Work Order ID 105207

Item Name: Crosstube Turning Detail

DART AEROSPACE LTD	Work Order:	105207
Description: Crosstube Assembly (205/212/412 High Fwd)	Part Number:	D212-664-141
Inspection Dwg: D212-664-141 Rev: D		Page 1 of 2

DRAWING NO. D212-664-141	TITLE XTUBE ASSY (205/212/412 HI FWD)	REV. D	DART AEROSPACE LTD ENGINEERING ORDER		D.E.O. NO. D212-664-141-D-1	SHEET NO. SHEET 1 OF 2	SCALE NTS
DRAWN	CHECKED	MFG. APPR.	APPROVED	DE APPR.			
DATE 11.04.07	DATE 11.04.11	DATE 11.04.12	DATE 11/04/12	DATE 11.04.12

**D212-664-141/-141B
ASSEMBLY DETAIL**

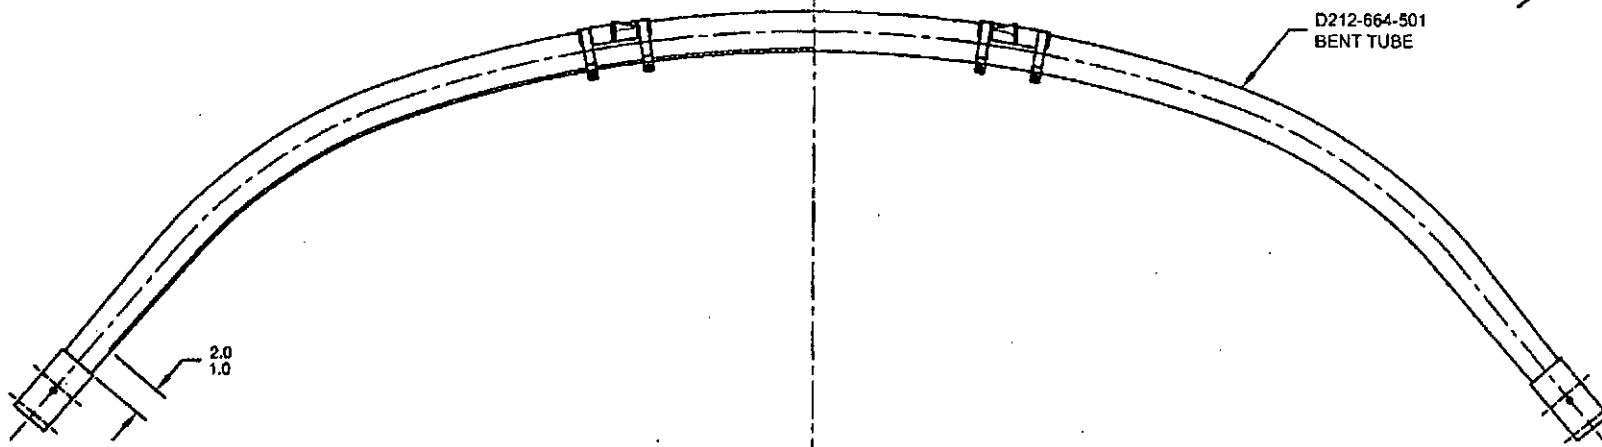
PURPOSE:

ADD AN INSPECTION WINDOW TO UNDERSIDE OF CROSSTUBE.

NOTES 2 OF SHEET 1 IS AMENDED AS FOLLOWS:

- 2) FINISH: CHEMICAL CONVERSION COAT PER DART QSI 005 4.1
PRIME INSIDE AND OUTSIDE PER DART QSI 005 4.2
MASK UNDERSIDE OF CROSSTUBE AS SHOWN (HATCHED AREA) AND
PAINT OUTSIDE PER DART QSI 005 4.2
REMOVE MASKING AND APPLY CLEAR COAT

- 2) FINISH: CHEMICAL CONVERSION COAT PER DART QSI 005 4.1
PRIME INSIDE AND OUTSIDE PER DART QSI 005 4.2
PAINT OUTSIDE PER DART QSI 005 4.2

MASK AREA PRIOR TO PAINTING.
REMOVE MASKING AFTER PAINT
AND APPLY CLEAR COAT
